**IDEA PUBLIC SCHOOLS – IDEA Owassa Phase II**

**ADDENDUM NO. 1**

June 28, 2019  
IDEA Owassa College Prep Phase II

## ADDENDUM NO. 1

**01 SITE PLAN IMPROVEMENTS**  
SCALE : 1"=50'

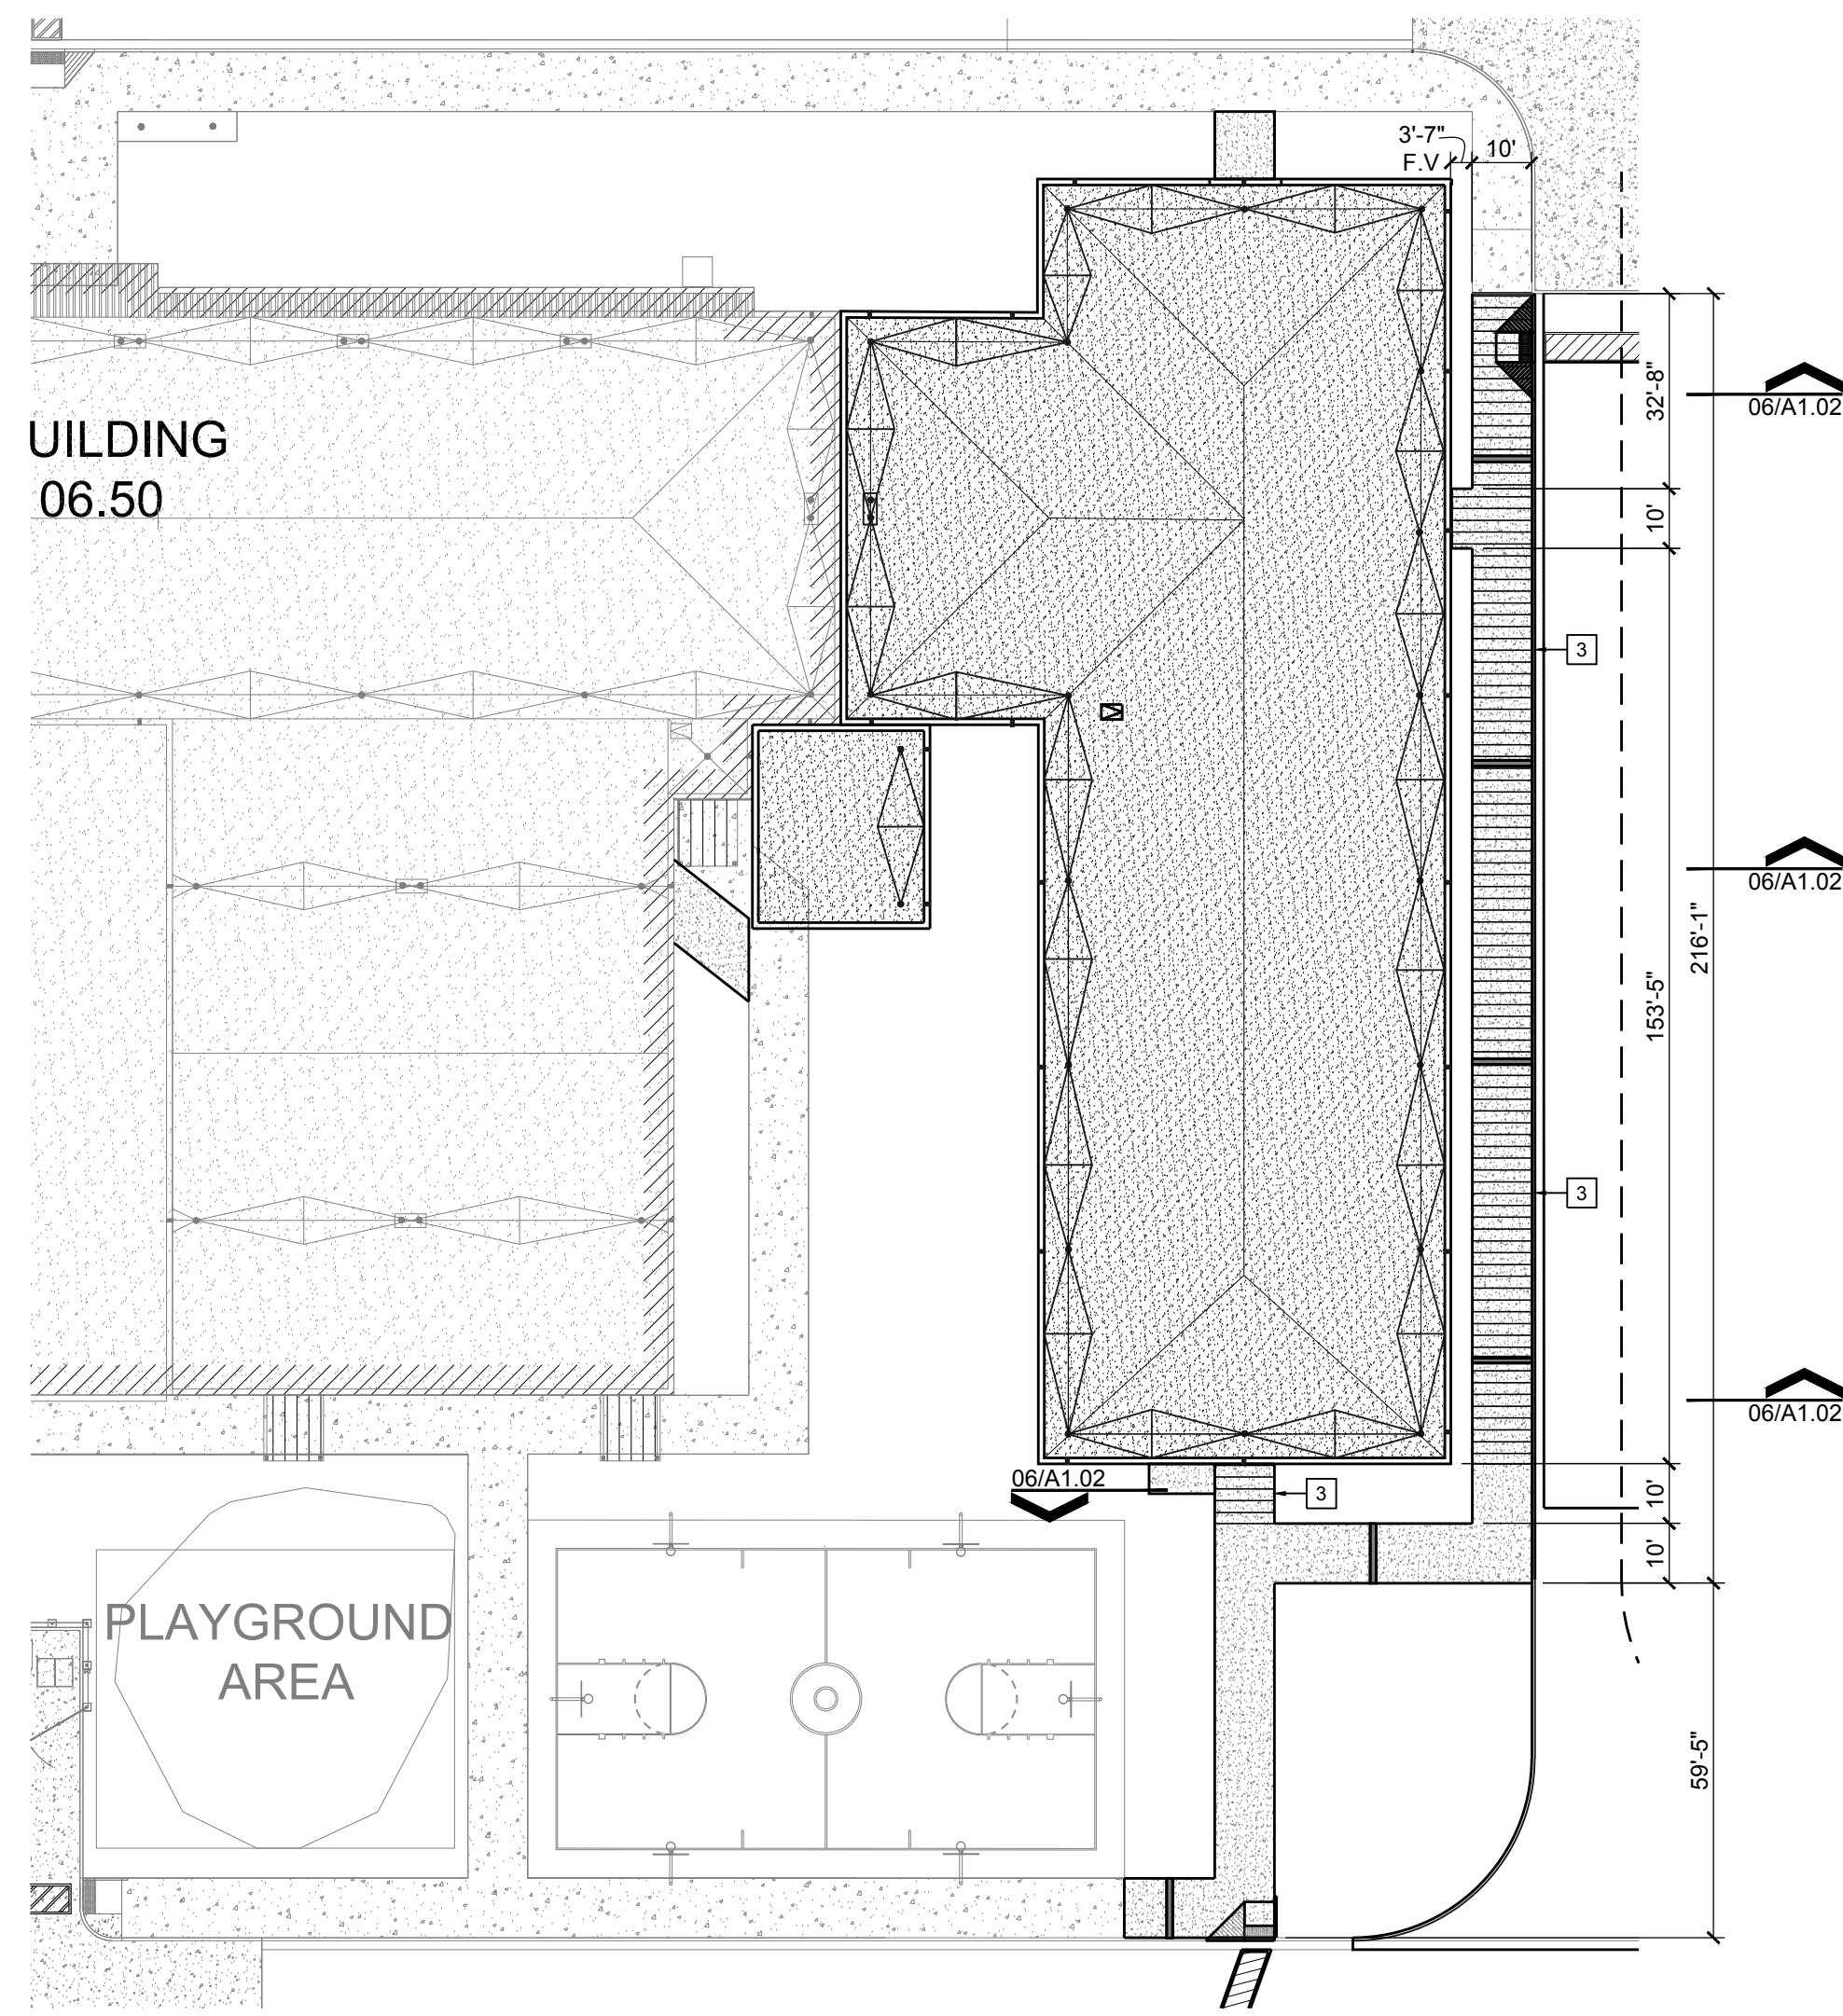
#### **1. Sheet A1.02 – Site Plan Improvements**

- a. REPLACE Sheet A1.02 Overall Site Plan previously issued with Sheet A1.02 Overall Site Plan Sheet included in this addendum.
- b. Key Note 22 – ADD the following to existing text: “Provide trail chaser plastic whiskers marking all painted soccer field stripe corners.
- c. ADD Key Note 24 – “Provide Trail Chaser Plastic Whiskers and HD Galv. Metal Stakes to mark jogging Trail @ 50’ O.C. Provide 4” painted field stripe connecting all markers for the full length of trail.”

- 23 PROVIDE TRAIL CHASER PLASTIC WHISKERS AND HD GALV METAL STAKES TO MARK JOGGING TRAIL @ 50' O.C. PROVIDE 4" PAINTED FIELD STRIPE CONNECTING ALL MARKERS FOR THE FULL LENGTH OF TRAIL
